REVISED SCHEMATIC NOVEMBER 1973

SOUND CITY AMPLIFIER TYPE L-B 50 PLUS

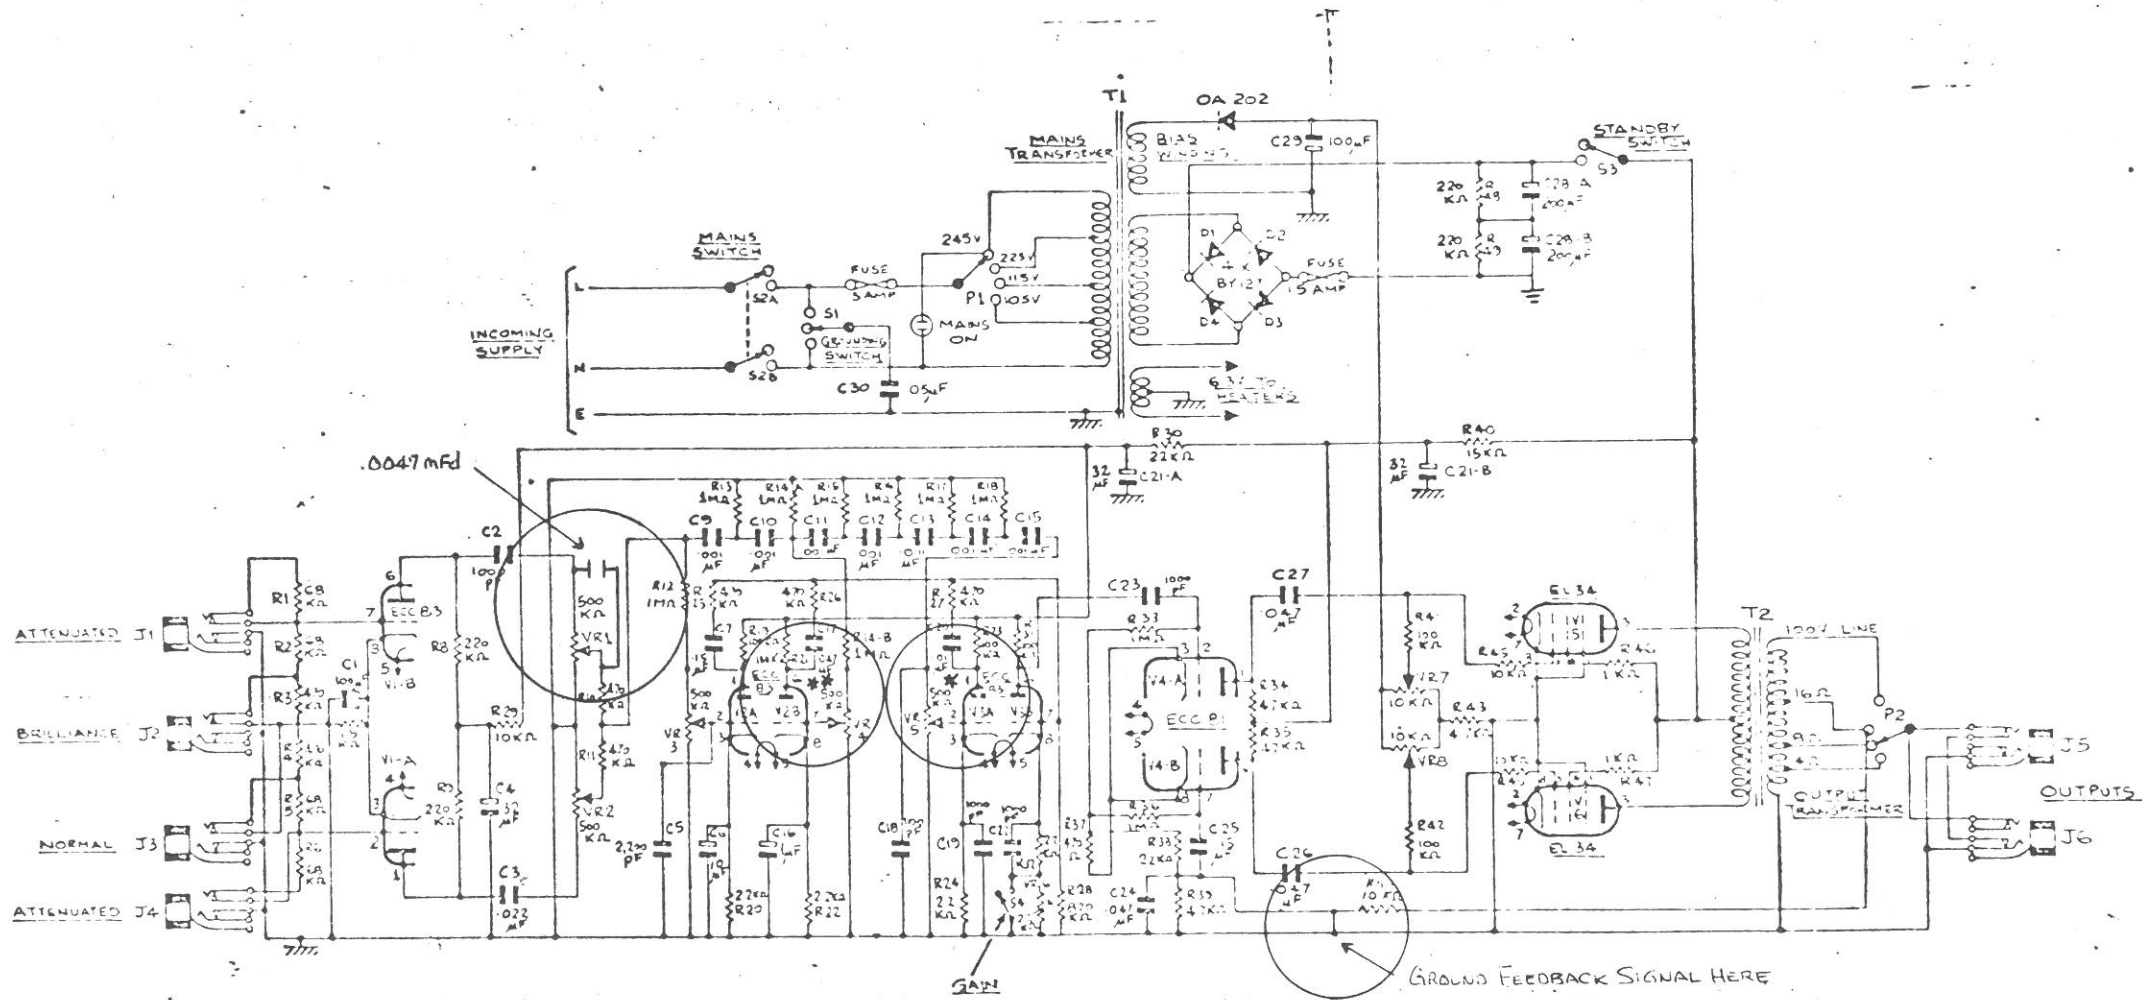
*To the plate of the treble pre-amp, add one nano Farad capacitor to ground.
 **To the plate of the middle pre-amp, add an .0047 mFd to ground.
